**BICESTER TO OXFORD TRANSPORT AND WORKS ACT ORDER
(TWA/10/APP/01) - DISCHARGE OF CONDITION 19 (VIBRATION
AND NOISE) AS IT RELATES TO SECTION H**

Annex 1 - Atkins Drawing No 5114534-ATK-DRG-MD-790203 Rev P01

Drawing Title
**WOLVERCOTE AREA
 S&C GEOMETRY
 CH 125473 TO CH 125607**

East West Rail Phase 1: Vibration Assessment for Proposed Relocation of Switches and Crossings in Section H

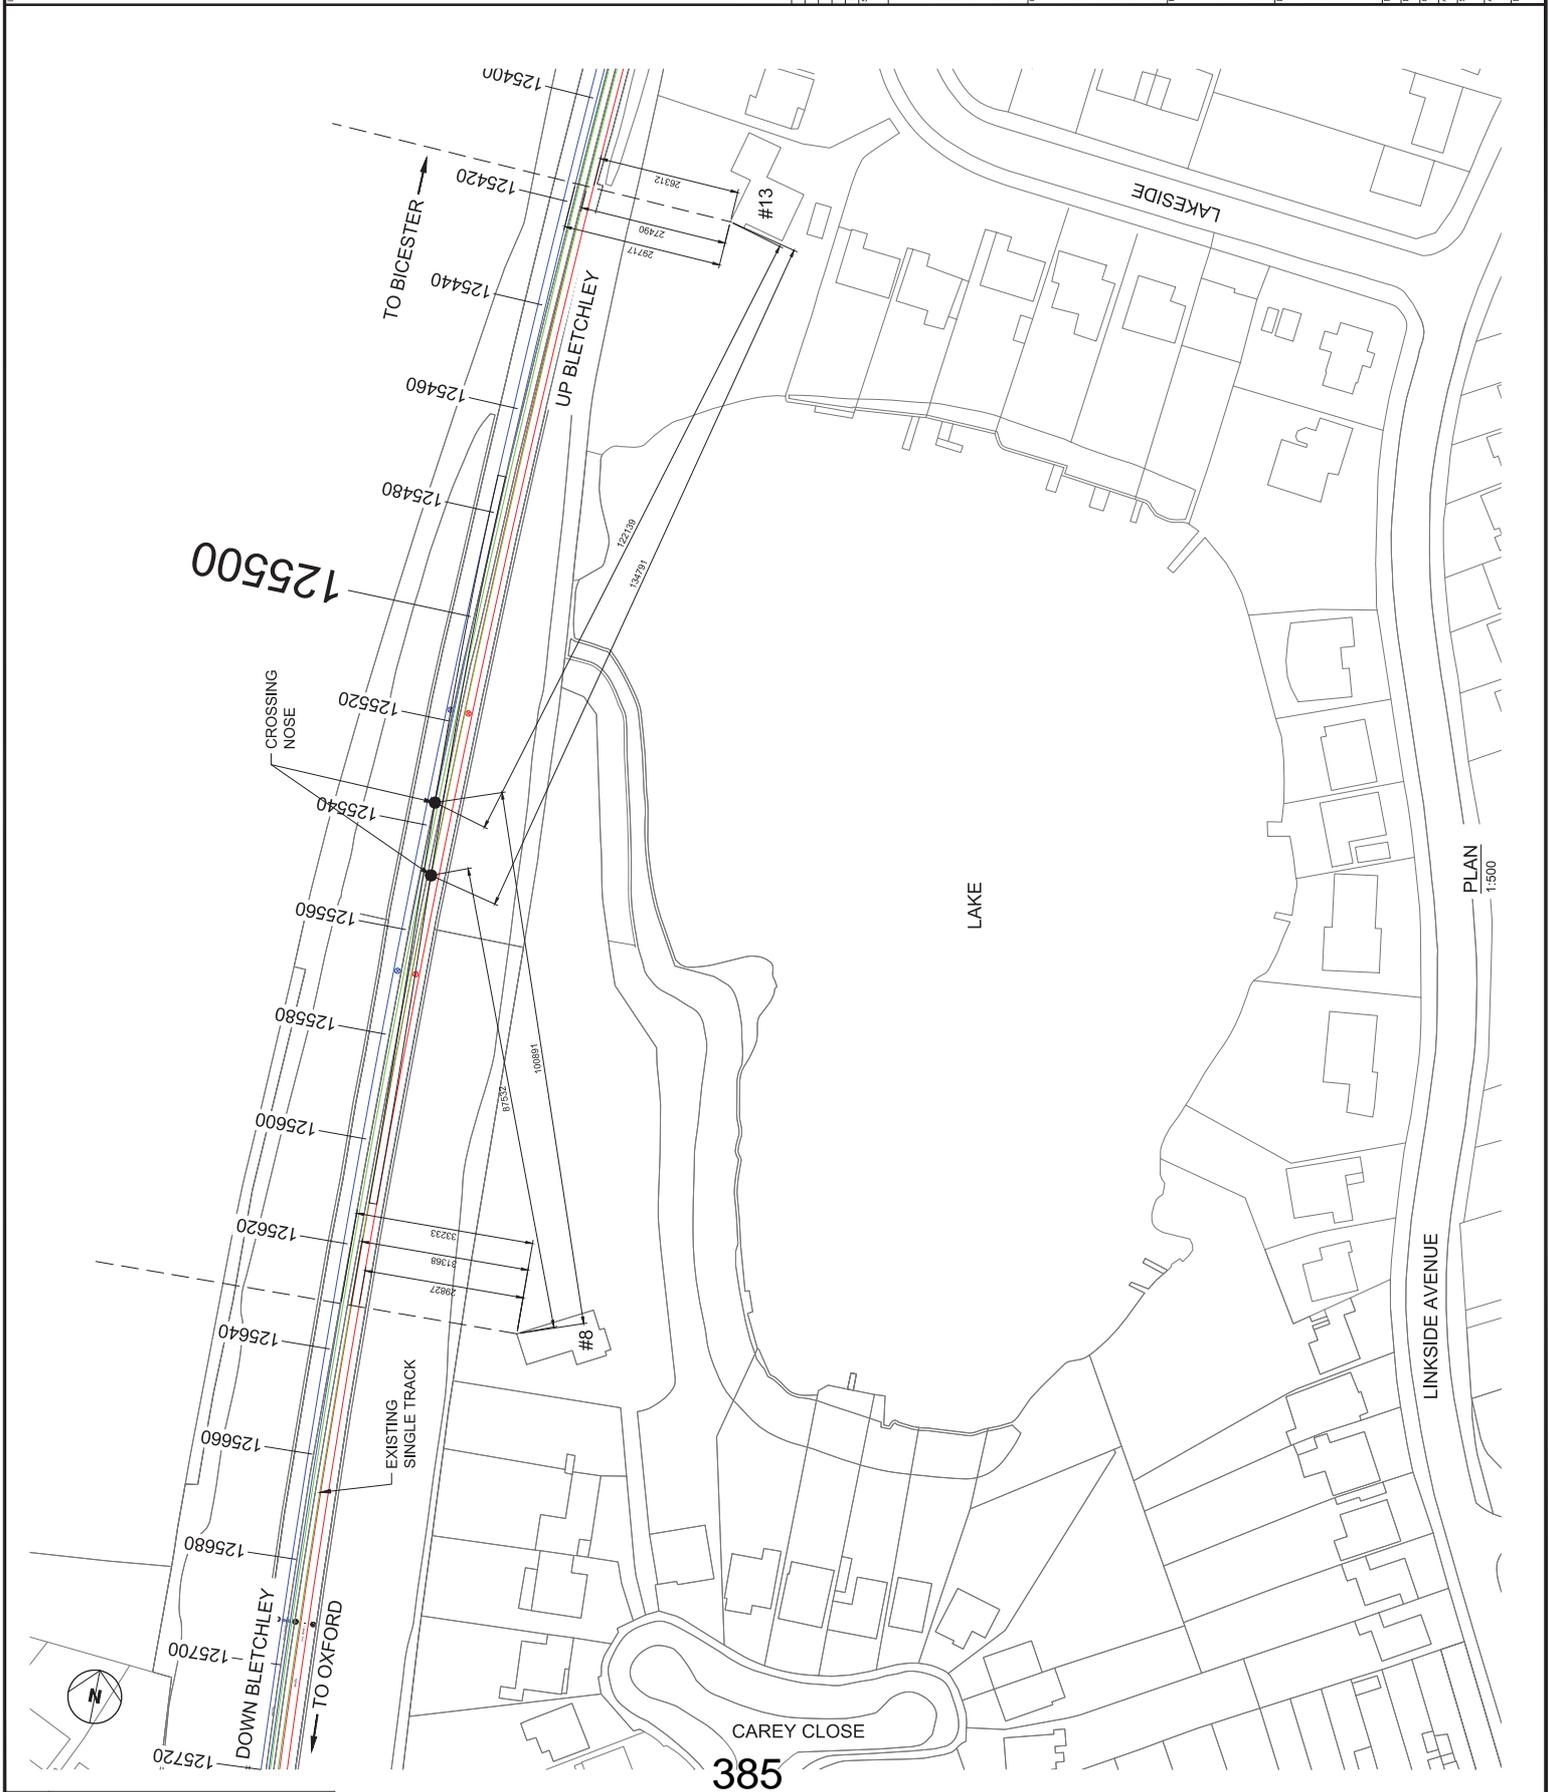
In order to secure approvals of the Vibration SoAs on 19 May, without recourse to speed limits, Network Rail is willing to agree not to install the proposed Switches and Crossing (S&C), which was proposed to be located in the vicinity of 4 Bladon Close (otherwise known as the Woodstock Road Crossover). The effect of this would be to bring the estimated Vibration Dose Values (VDVs) at 4 Bladon Close well within the Scheme limits during both day and night periods.

The Project now proposes to relocate the S&C to a position further north, but still within Section H, at Lakeside. The general layout of the proposed S&C is shown on Atkins drawing no 5114534-ATK-DRG-MD-790203 Rev P01 – chainage 125550, attached here as Annex 1. This location has been chosen in order to be well away from nearby residential (and commercial) properties.

The relocation of the S&C as outlined above will therefore address the potential exceedances at 4 Bladon Close, noted in Andy Milne's letter of 2 April 2015, and will not result in any adverse impacts at the new location, because of the much greater distances from the nearest residential property.

Atkins has undertaken a further vibration assessment for the proposed relocation, attached here in full as Annex 2 (*East West Rail Phase 1: Vibration Assessment for Proposed Relocation of Switches and Crossings in Section H*). This assesses the potential vibration impacts on the nearest property to the S&C, which is identified as 8 Carey Close. This property is located approximately 87.5m and 100m south of the 2 relevant parts of the crossing.

The assessment shows that, based on both the typical transfer functions and the worst-case transfer functions, the estimated VDVs at 8 Carey Close are well within the Scheme vibration threshold limits.
